DRAWN BY: D.E. WATTS
DATE: 4-2-21
DWG. NO.: 20-5509-06
SURVEYED BY: DEW, ESW, 6-26-19, 9-24-20

PROJECT 10659 MALTESE POINT
LOT 11, ROLLING THUNDER BUSINESS PARK
EL PASO COUNTY

SHT. NAME GRADING AND EROSION CONTROL PLAN

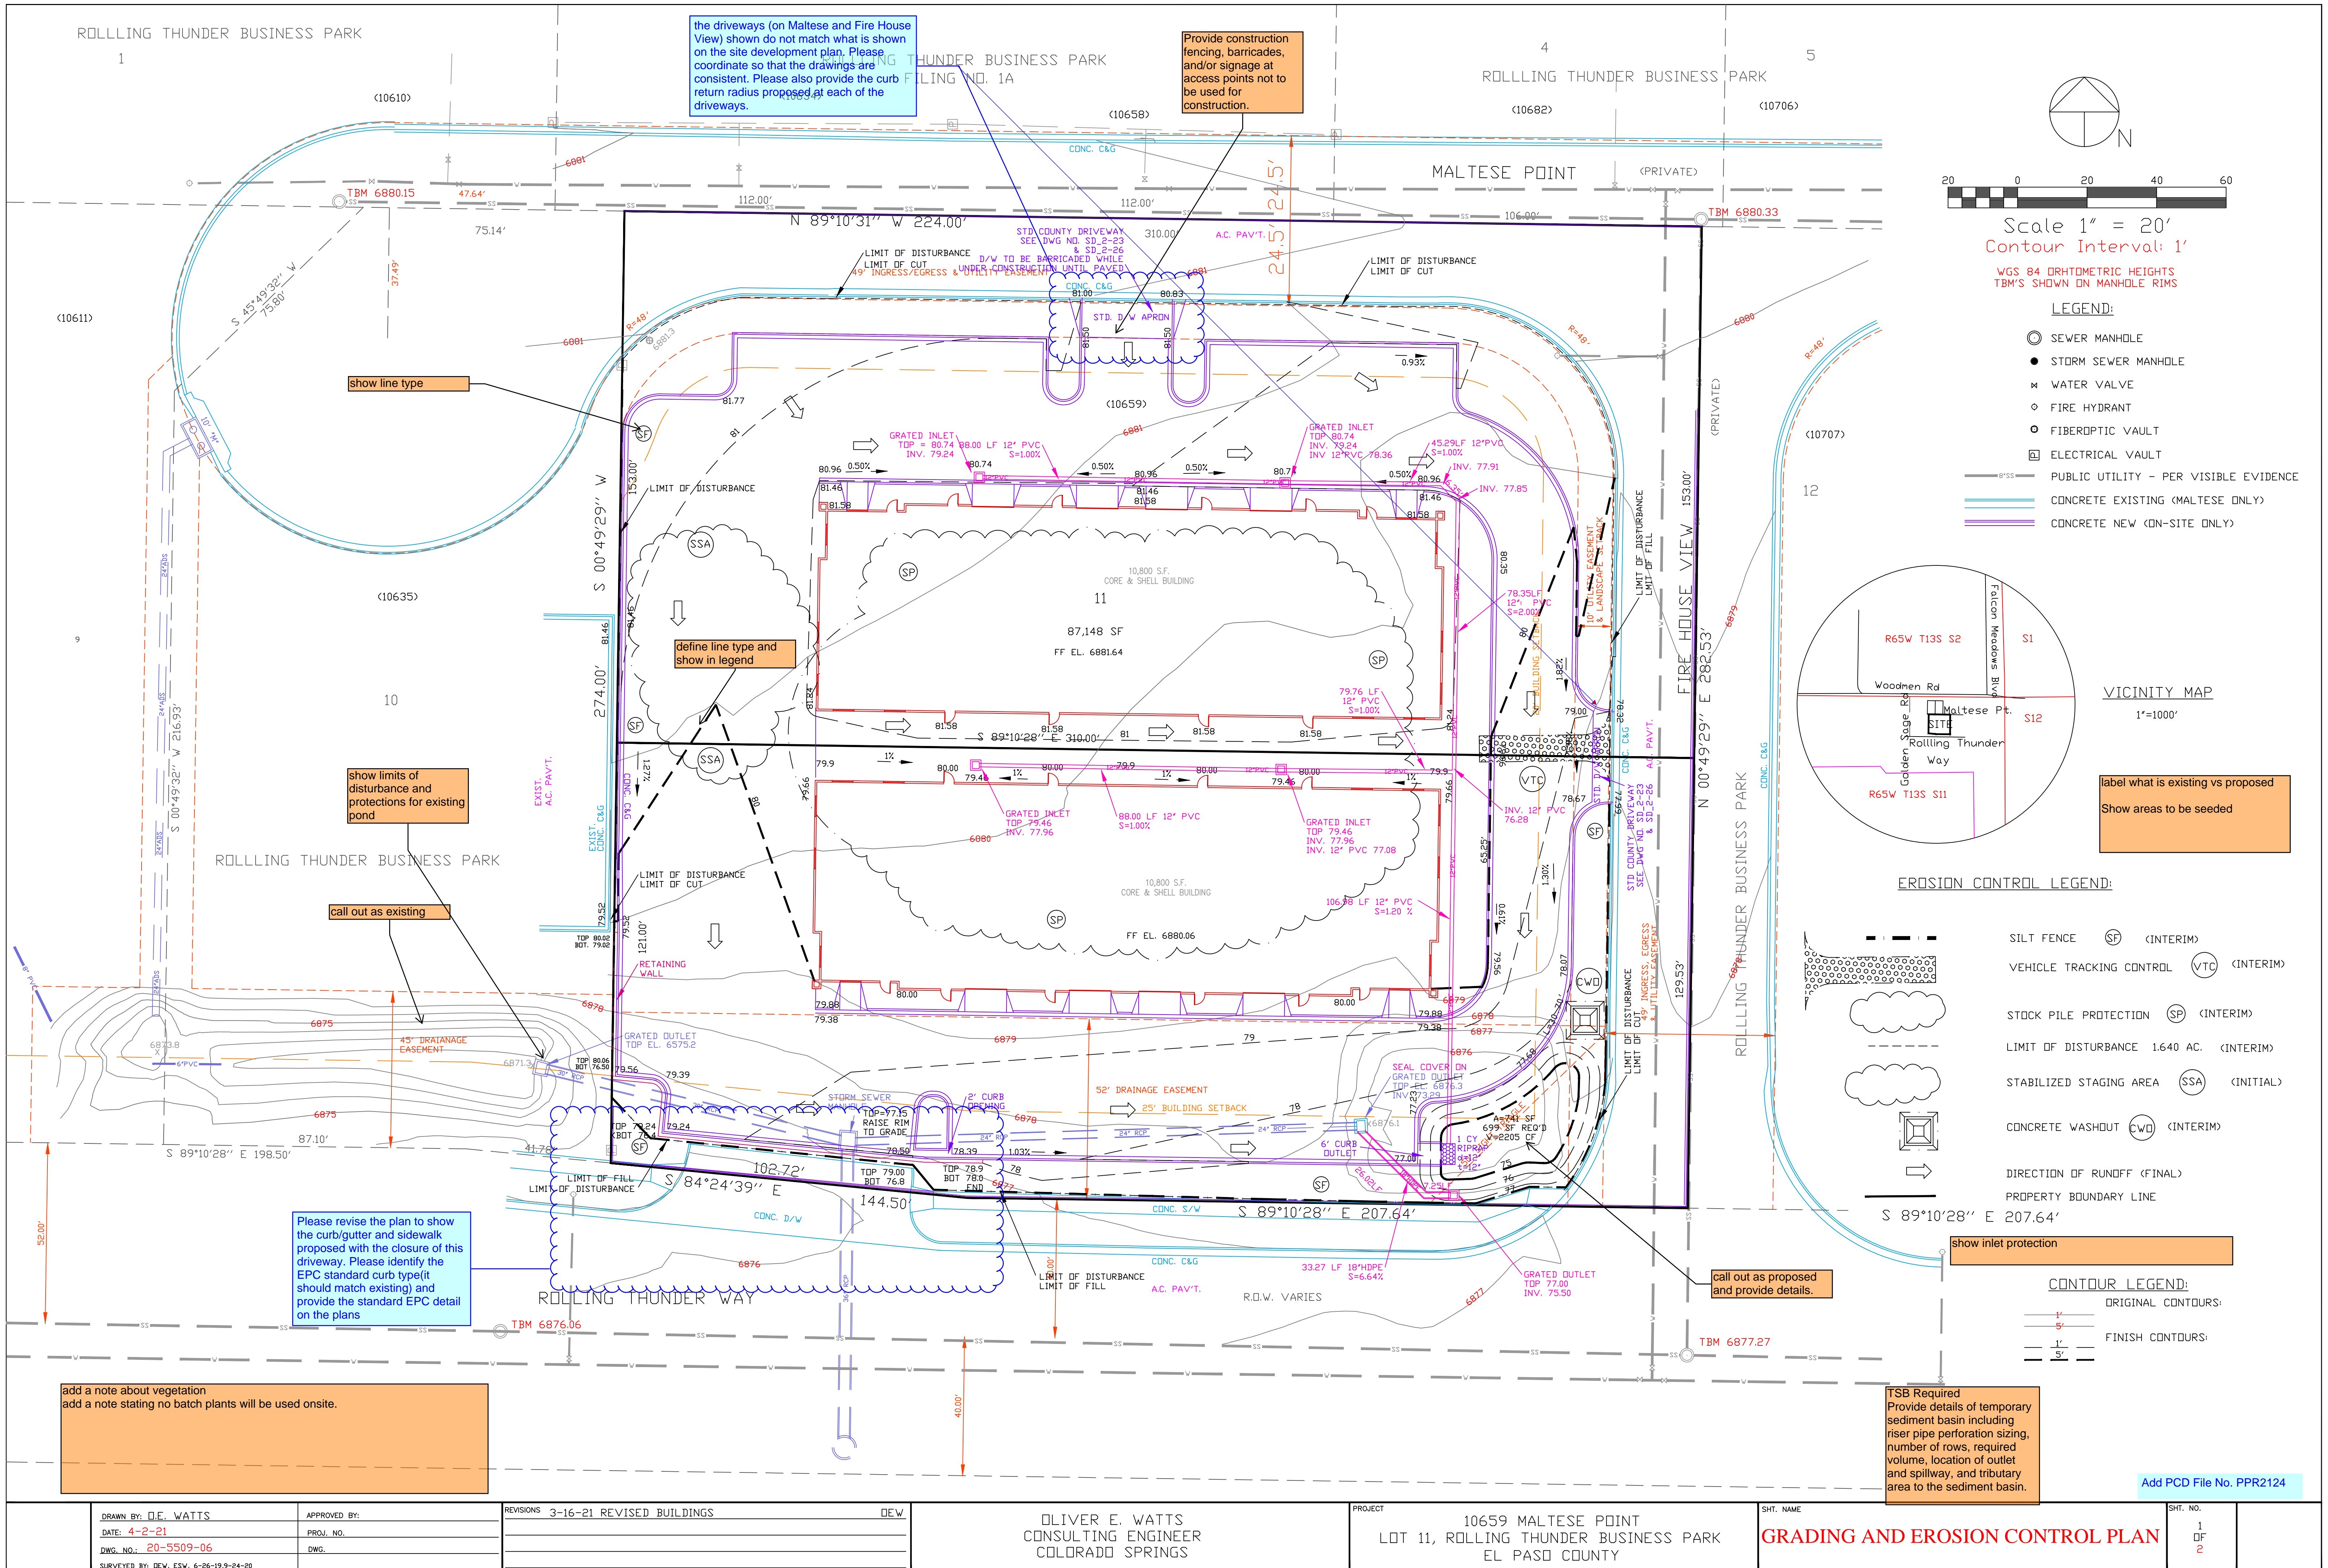
the driveways (on Maltese and Fire House View) shown do not match what is shown on the site development plan. Please coordinate so that the drawings are consistent. Please also provide the curb return radius proposed at each of the driveways.

Provide construction fencing, barricades, and/or signage at access points not to be used for construction.

show line type

define line type and show in legend

show limits of disturbance and protections for existing pond

call out as existing

Please revise the plan to show the curb/gutter and sidewalk proposed with the closure of this driveway. Please identify the EPC standard curb type(it should match existing) and provide the standard EPC detail on the plans

add a note about vegetation
add a note stating no batch plants will be used onsite.

call out as proposed and provide details.

show inlet protection

label what is existing vs proposed
Show areas to be seeded

TSB Required
Provide details of temporary sediment basin including riser pipe perforation sizing, number of rows, required volume, location of outlet and spillway, and tributary area to the sediment basin.

Add PCD File No. PPR2124
